PCS Responses to comments below:

Re: Second Submission Review – Urban Cottages Jewell – Zoning Map Amendment, Site Plan w/Adjustment and Final Plat
Application Number: **DA-2309-00**
Case Numbers: **1984-2057; 2022-4026-00; 2022-3022-00**

URBAN COTTAGES JEWELL SITE PLAN

SECTION 1:
POND RETAINING WALL SECTION
SCALE: N.T.S.

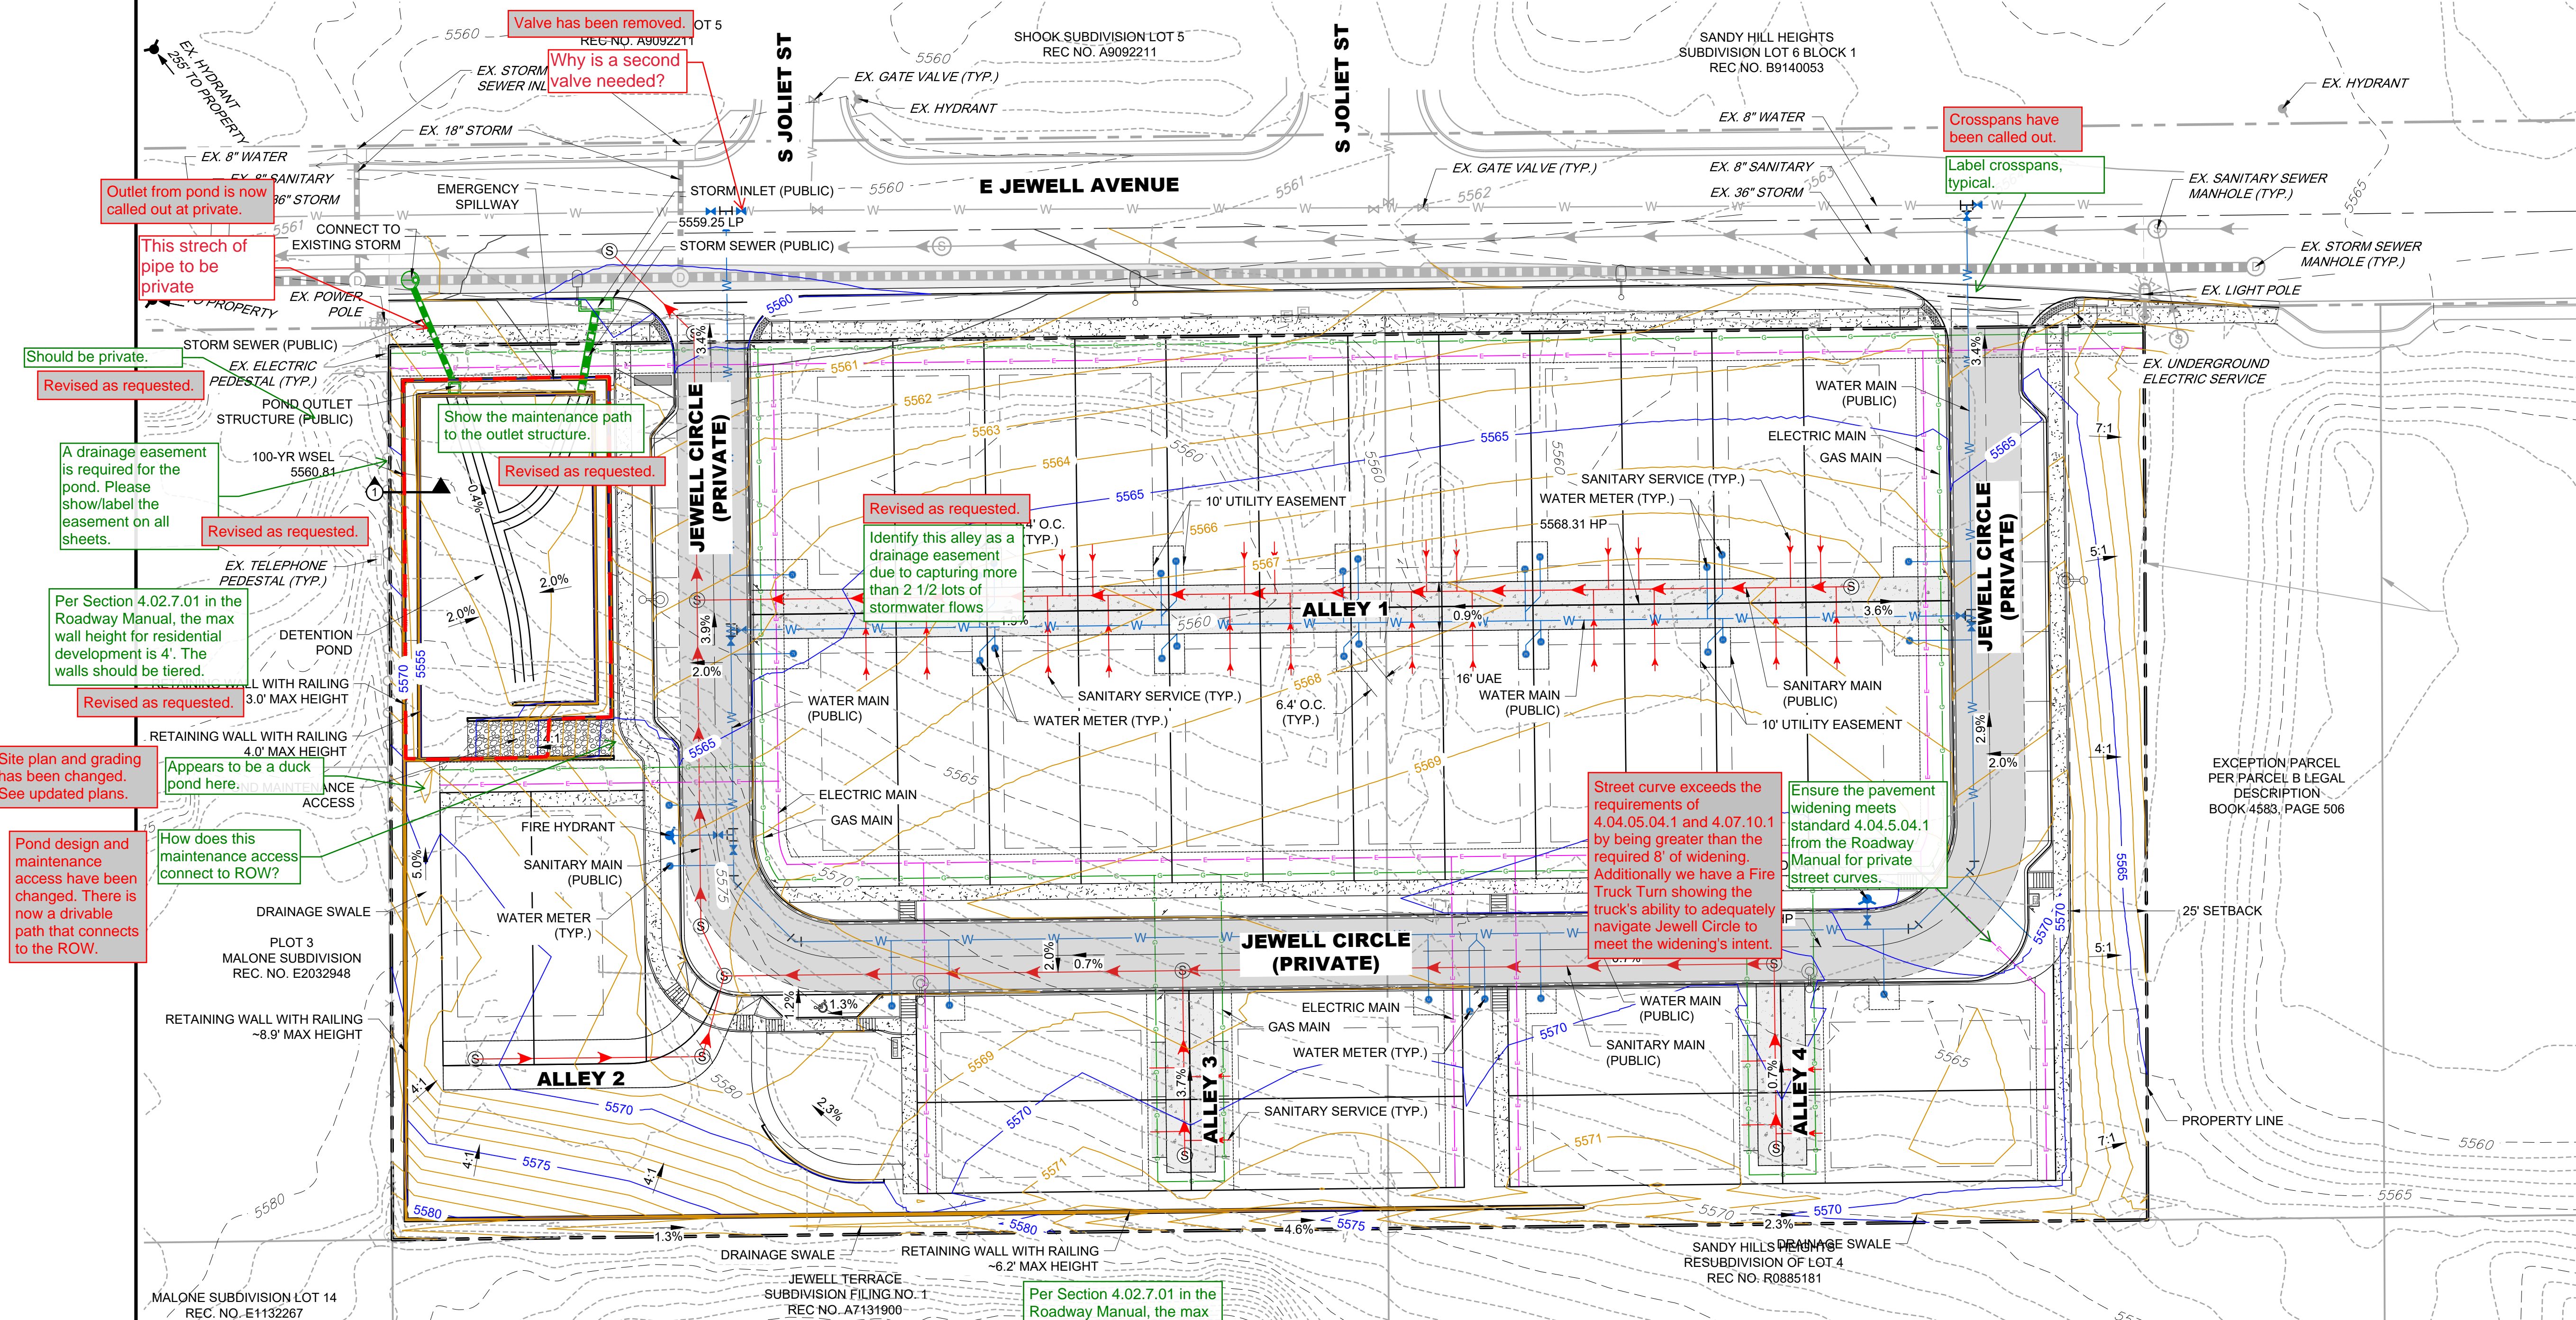
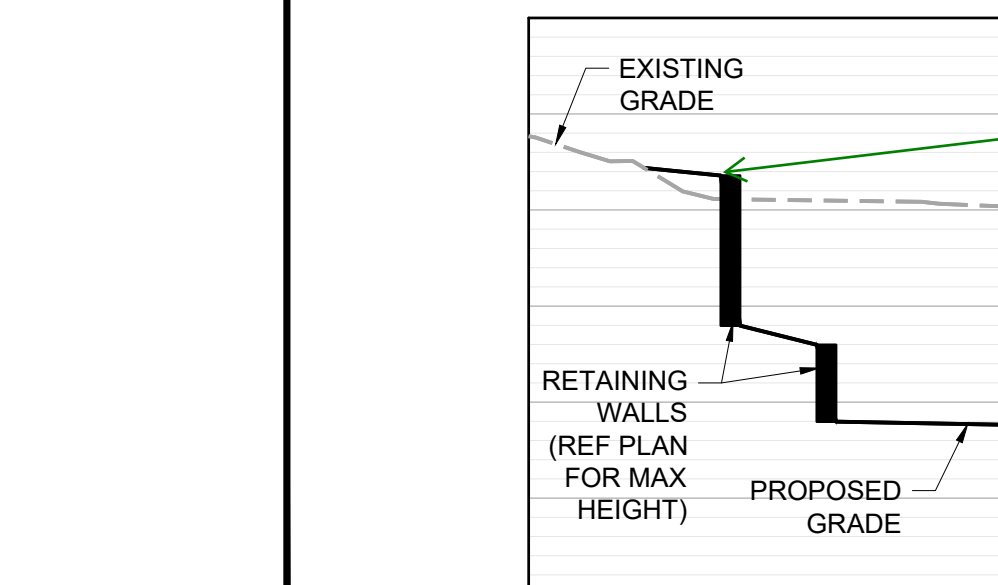
Show railing for the retaining wall. Include the material for the wall in the section.

Revised as requested.

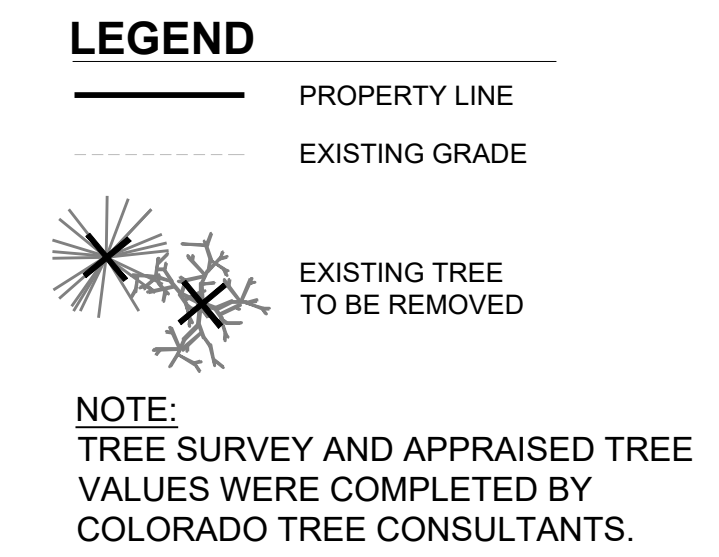
Ensure the pavement widening meets standard 4.04.5.04.1 from the Roadway Manual for private street curves.

Street curve exceeds the requirements of 4.04.05.04.1 and 4.07.10.1 by being greater than the required 8' of widening. Additionally we have a Fire Truck Turn showing the truck's ability to adequately navigate Jewell Circle to meet the widening's intent.
